NOVA SCOTIA ENERGY BOARD**IN THE MATTER OF:** *The Public Utilities Act***IN THE MATTER OF:** **An Application by EfficiencyOne for approval of the 2027-2031 Demand-Side Management (DSM) Purchase Agreement between EfficiencyOne and Nova Scotia Power Incorporated, the establishment of a final agreement between the parties, and approval of a 2027-2031 Demand-Side Management (DSM) Resource Plan****INFORMATION REQUESTS****To:** EfficiencyOne ("E1")**From:** The Industrial Group**Responses Due:** May 28, 2026**Contact Person** Nancy G. Rubin, K.C.
 Brianne Rudderham
 Stewart McKelvey
 Suite 600-1741 Lower Water Street
 P.O. Box 997
 Halifax NS B3J 2X2
 Telephone: (902) 420-3200 / Fax (902) 420-1417Issued at Halifax, Nova Scotia, this 7th day of May 2026.**Request IR-1:****References:** Exhibit E-1, Application, page 8/71, lines 23–24; and Table 15, pages 40–44/71.**Preamble:** E1 states that annual investment is constrained to the 2026 approved level of \$63.75M per year, with no inflationary increases applied.

Figure 4: Payback Analysis – Preferred Plan

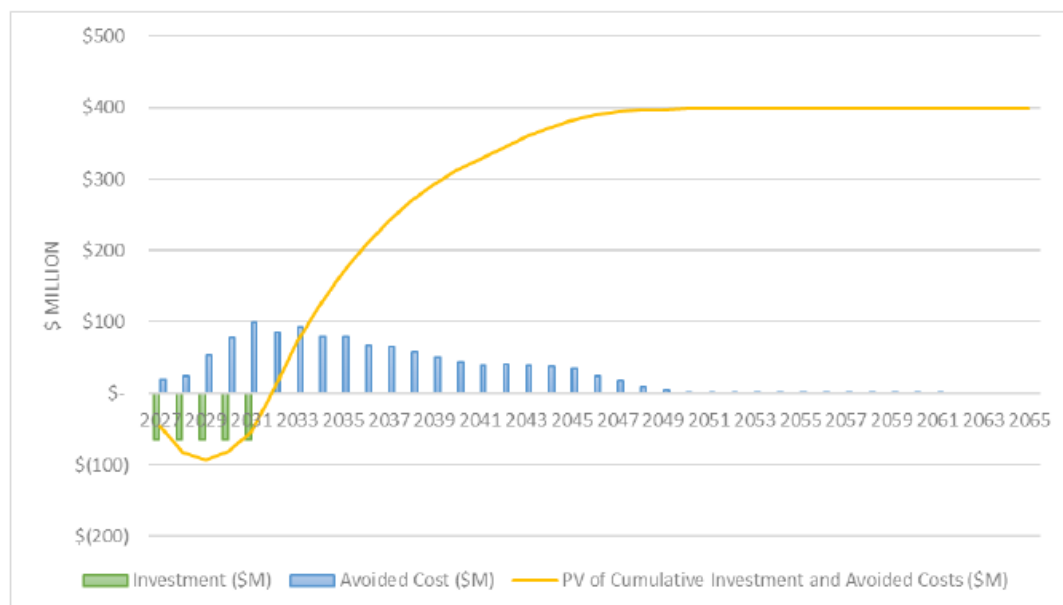
- 1 (a) Does this reflect current approved rates in the 2027-2028 GRA? If not,
2 please explain.
- 3 (b) Please provide a version of Exhibit E-1(ii) for the Alternate Scenario (in
4 excel format).

- 5 (c) Please provide the measure level payback analysis as per Exhibit E-1-(ii)
6 "Simple Payback Review" tab and an updated Figure 4 (reproduced above)
7 for the Alternate Scenario.
